Proposed Revisions to 100GBASE-LR Baseline Proposal

Brian Welch (Cisco)

Overview

Proposed 100GBASE-LR Receiver Specifications

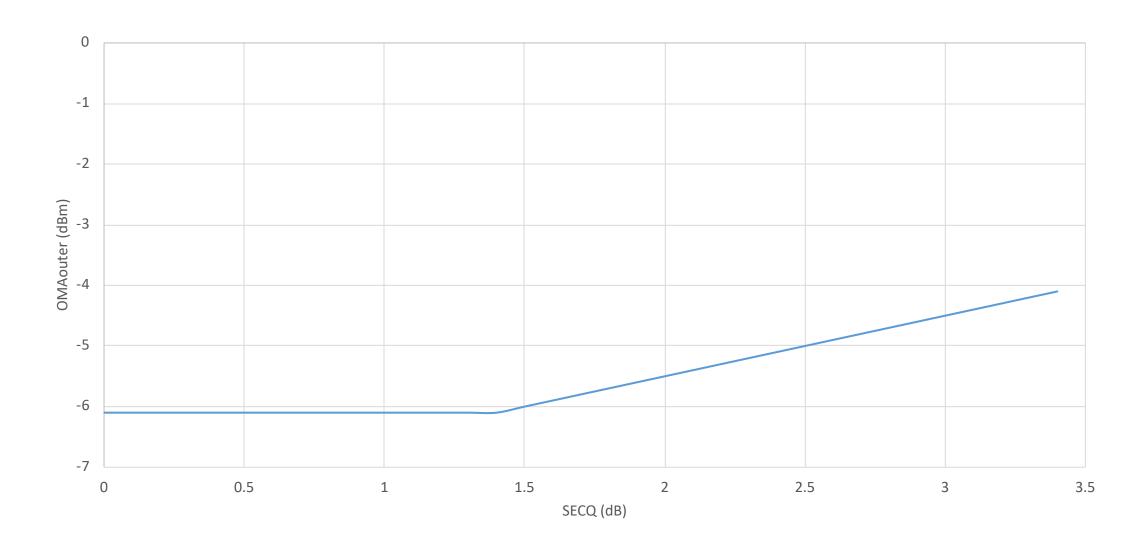
- In May 802.3cu meetings the following motion passed:
 Move to adopt a baseline for the "single-wavelength 100 Gb/s PHY for operation over SMF withlengths up to at least 10 km" objective based on the proposal in welch_3cu_02b_0519.pdf with the inclusion of additional penalty due to 5 ps DGD_max as outlined in anslow_3cu_01_0519.pdf
- This requires 0.25 dB of additional link budget to be allocated for DGD
- The following slides contain a proposal for how that could be accommodated
 - Shifting the transmitter specifications up by 0.25 dB where applicable
 - Changes indicated in red.

Description	100GBase-LR (Baseline)	100GBase-LR (Proposed)	Unit
PAM4 Signaling rate, (range)	53.125 ± 100 ppm	53.125 ± 100 ppm	GBd
Wavelength (range)	1304.5 to 1317.5	1304.5 to 1317.5	nm
Damage threshold, (min) ^a	5.5	5.75	dBm
Average receive power, (max)	4.5	4.75	dBm
Average receive power, ^b (min)	-7.7	-7.7	dBm
Receive power, (OMA _{outer}) (max)	4.7	4.95	dBm
Receiver reflectance (max)	-26	-26	dB
Receiver sensitivity (OMA _{outer}), ^c (max)	= max(-6.1, SECQ-7.5)	= max(-6.1, SECQ-7.5)	dBm
Stressed receiver sensitivity (OMA _{outer}), d (max)	-4.1	-4.1	dBm
Conditions of stressed receiver sensitivity test ^e :	•	•	•
Stressed eye closure for PAM4 (SECQ)	3.4	3.4	dB
SECQ – 10*log ₁₀ (C _{eq}) (max) ^e	3.4	3.4	dB
^a The receiver shall be able to tolerate, without damage, continuous exposure to a	an ontical signal having this average nower level. The rece	iver does not have to operate correctly a	nt this innut
